Dear Reviewer:

We gratefully thank you for your constructive remarks and useful suggestions, which have significantly improved the quality of the manuscript and have enabled us to refine it. Below are our responses to the reviewers' comments, point by point, and the revisions are indicated.

Fig. 1. PSRW in south-western China (a) Kongyu town (b) Jiuzhaigou nature reserve (c) Zhenjiangguan tunnel exit in Chengdu-lanzhou railway (d) Zhangmu town

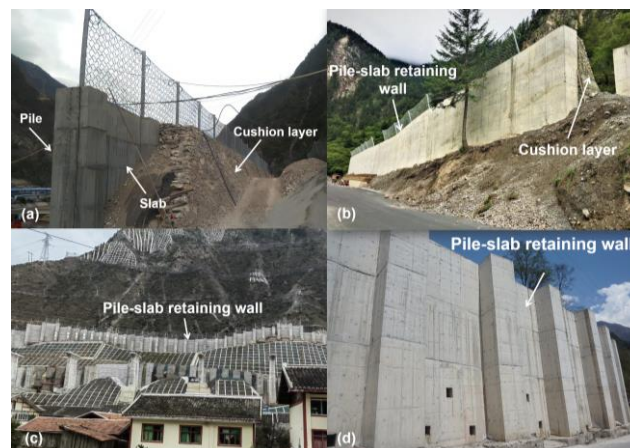
However, the research question connected to the PSRW (pile slab retaining wall) may be better highlighted in the introduction, by placing it in a separate paragraph, together with the figures.

We are deeply grateful for your invaluable suggestions. After meticulous consideration, we have revised the capacity of this section. The revised content is presented below:

In response to the challenges posed by steep terrains, narrow site conditions, and suboptimal foundation conditions in mountainous terrain, Hu et al. (2019) introduced the PSRW structure. This structure comprises a buffer layer and an anti-slide pile-slab system, which has found widespread application in southwestern China (Fig. 1). Due to the use of pile foundations, this structure exhibits characteristics such as a small footprint, high interception height, and ease of construction.
